PUBLIC ADVOCATES OFFICE
CALIFORNIA PUBLIC UTILITIES COMMISSION

**REPORT ON PLANT FOR NORTHERN AND
CENTRAL DIVISIONS AND TANK PAINTING**

CALIFORNIA AMERICAN WATER COMPANY
General Rate Case Application 22-07-001
Test Year 2024

San Francisco, California
April 13, 2023

Table 1-2: Manganese Concentration – Wittkop Well 2⁸⁶

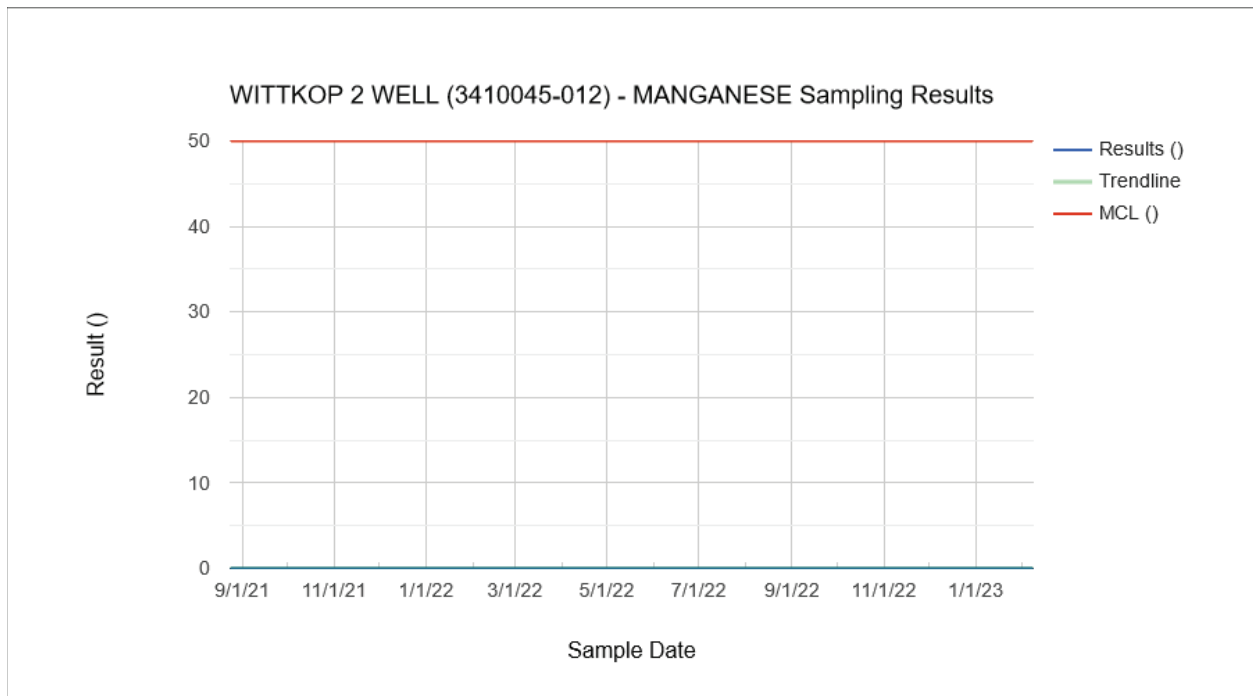
4 As shown in Table 1-2 above, the manganese level is non-detect. Since the
5 manganese level has been consistently below the SMCL, the proposed treatment is not
6 necessary. Therefore, the Commission should reject Cal Am’s request.
